Equalizer Nomenclature, Description, and Eye Diagram Generation

IEEE 802.3dj May Meeting

Comments Addressed: I-180, I-224, I-391, I-393, I-396, I-463

Figure 180-11—Illustration of the TDECQ measurement

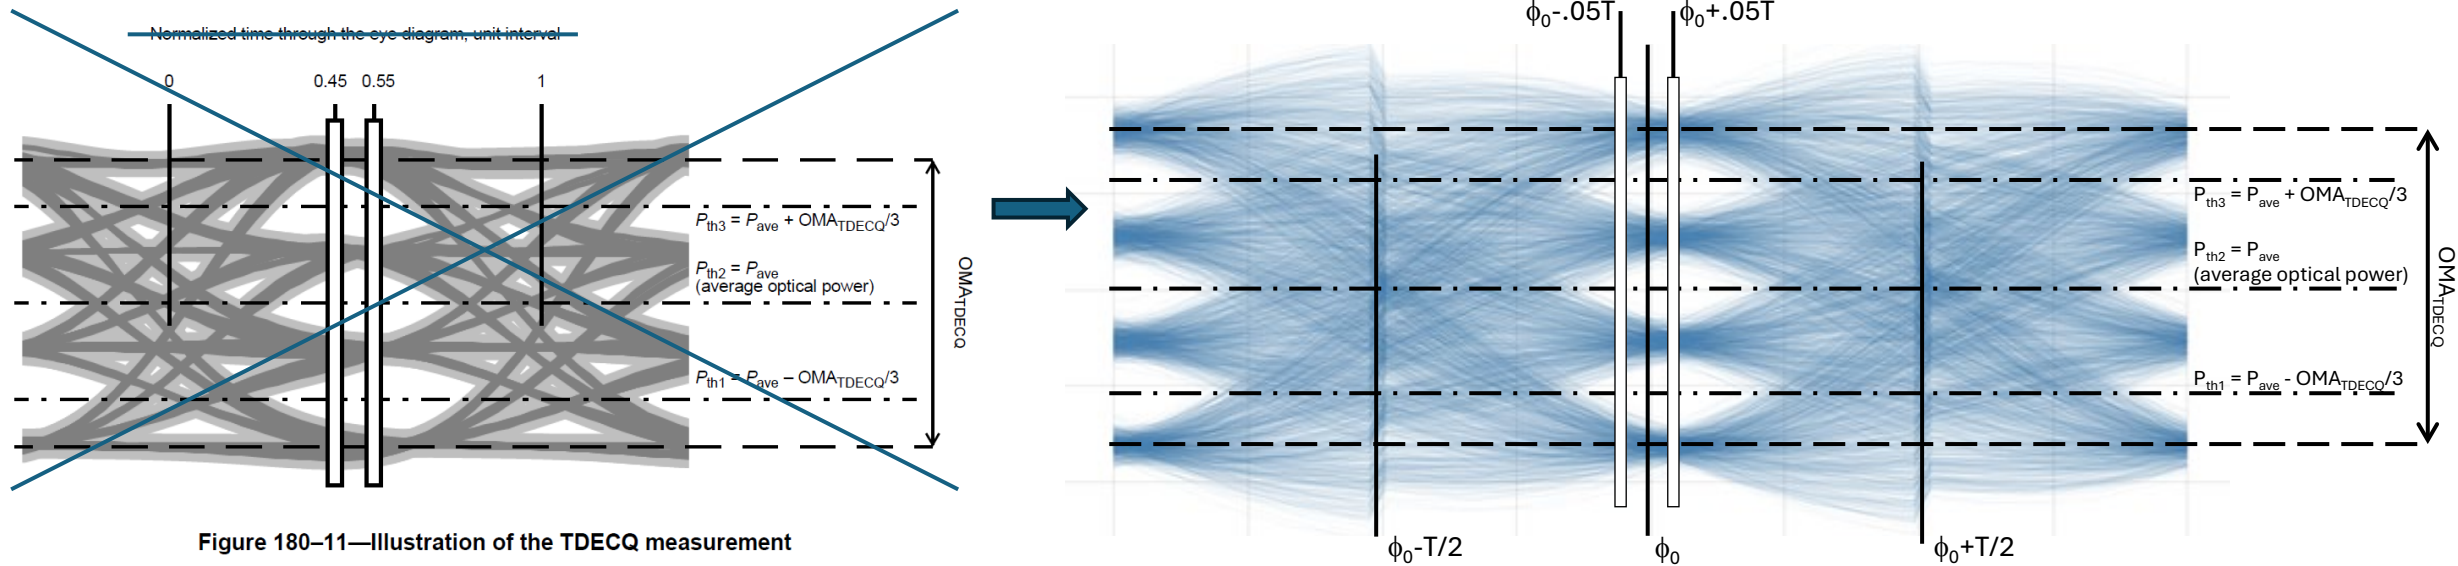
as follows. For a given sampling phase ϕ_0 , optimize the equalizer coefficients $\mathbf{w} = [w(a) w(a + 1) \dots w(a + 14)]$ and b . With the coefficients fixed, sweep the sampling phase from $\phi_0 - \frac{T}{2}$ to $\phi_0 + \frac{T}{2}$, and for each phase plot the scatter plot of the y_n values resulting from the test pattern sequence. An example eye diagram is shown in Figure 180-11. The feedback symbol $x(n)$ changes at phase $\phi = \phi_0 - \frac{T}{2}$. Note: the Gaussian noise $\eta(t)$ added to $r(t)$ in Figure 180-10 is not reflected in the eye diagram; it is accounted for separately when estimating the SER in the analysis block.

Two vertical histograms are measured through the eye diagram, nominally centered at ~~0.45 UI and 0.55 UI~~ \rightarrow $\phi_0 - 0.05T$ and $\phi_0 + 0.05T$. Each of the histogram windows spans all of the modulation levels of the eye diagram, as illustrated in Figure 180-11. The precise time position of the pair of histograms is adjusted to minimize TDECQ while keeping the histograms spaced 0.1 UI apart.

What is the origin of the eye diagram?

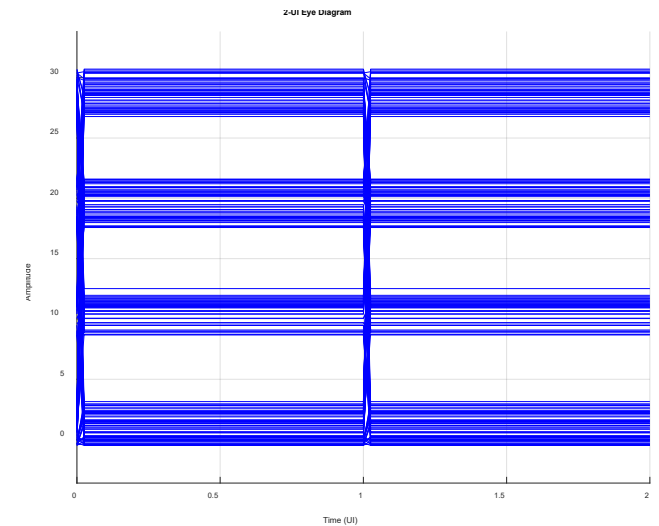
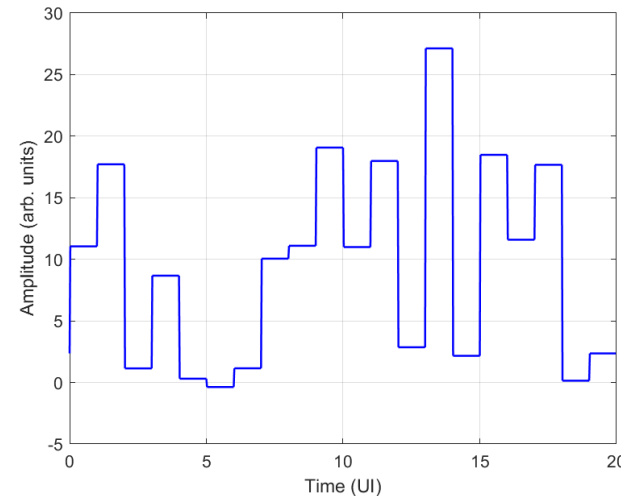
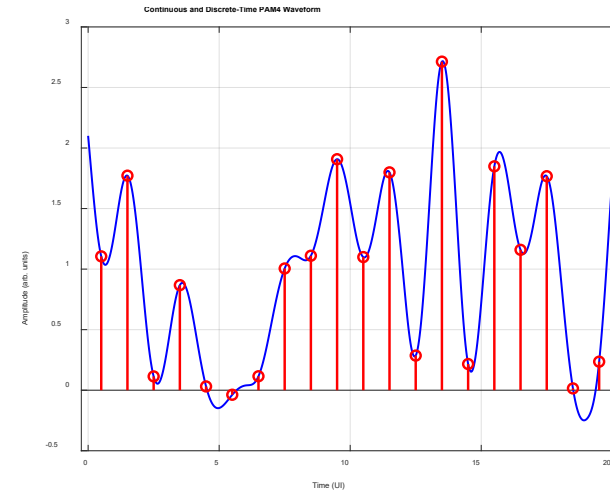
- A discrete-time equalizer has no eye diagram
 - A discrete-time signal is not defined in between samples
- Or you could say it has a “boring” eye diagram if you maintain that the signal stays constant between samples

Figure 180–10—TDECQ reference equalizer functional model

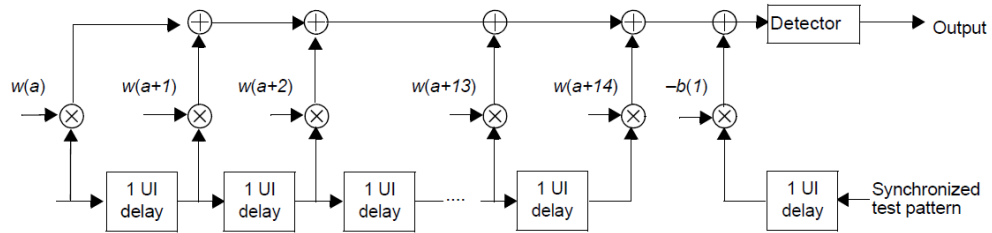
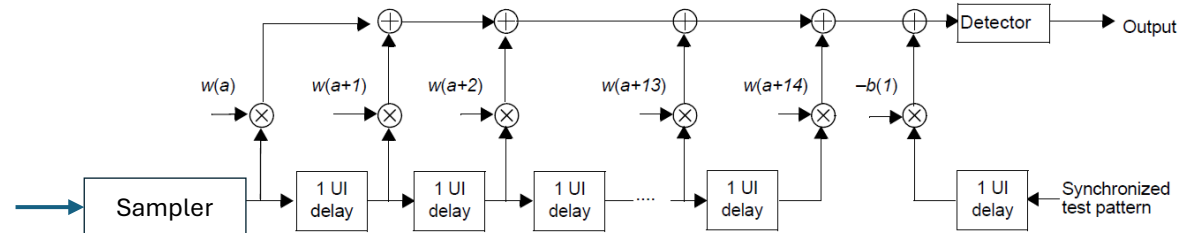
- 1) Continuous time equalizer

- Taps are adjusted based on 1UI - spaced samples
- Components shown are ideal (infinite bandwidth)

- 2) Discrete time equalizer

- 1UI –spaced Sampler is at the input
- For a given tap setting, the phase of the sampler can be swept to produce the eye diagram

Figure 180-11—Illustration of the TDECQ measurement

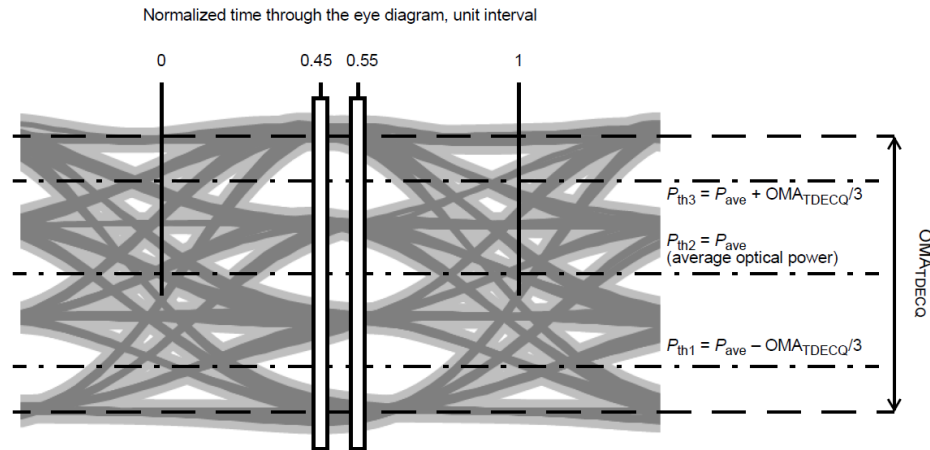
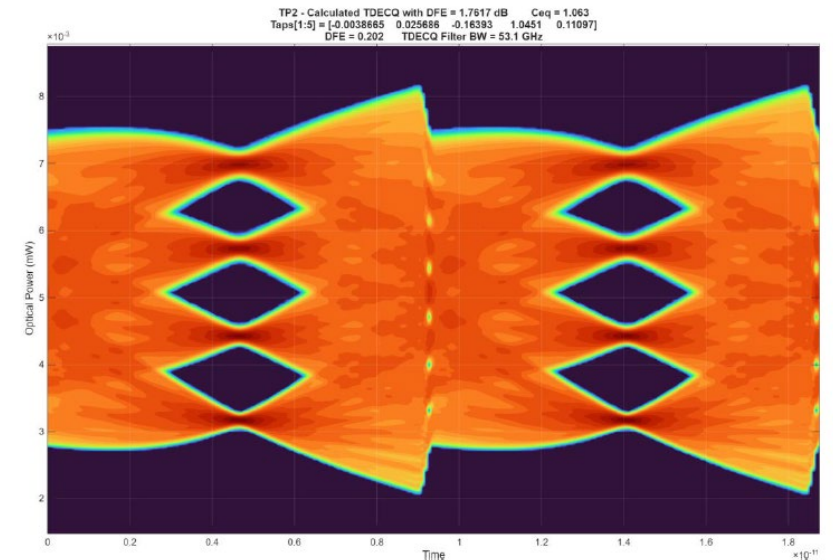
- However we define it, we need to include the “bat-wing” if we show the eye diagram
 - This is a unique feature of the DFE eye diagram. The amount added to the waveform is constant over 1UI.
- Timing: The value must change outside of the two histogram windows
 - Nominally $\frac{1}{2}$ UI from the center eye opening is a good choice
 - We need to say something about this in the text
 - Perhaps “1/2 UI from the nominal point at which the TDECQ is measured”
 - This needs better description in the text and figure

Comments I-391 (Swenson), I-224 (Maniloff)

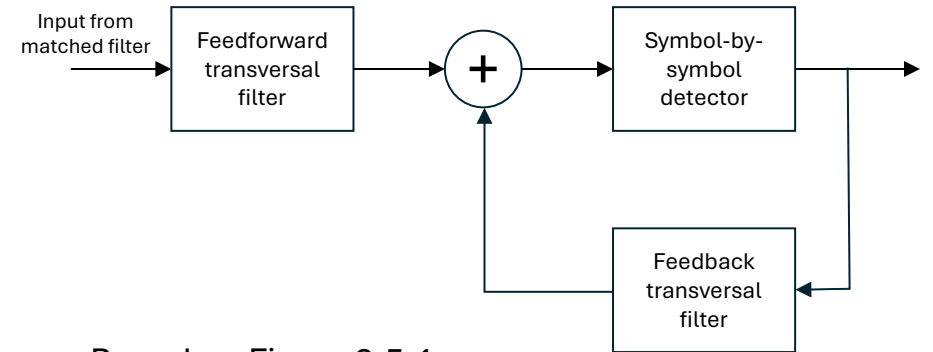
Suggested resolution: Some mutually acceptable combination of the two suggested remedies.
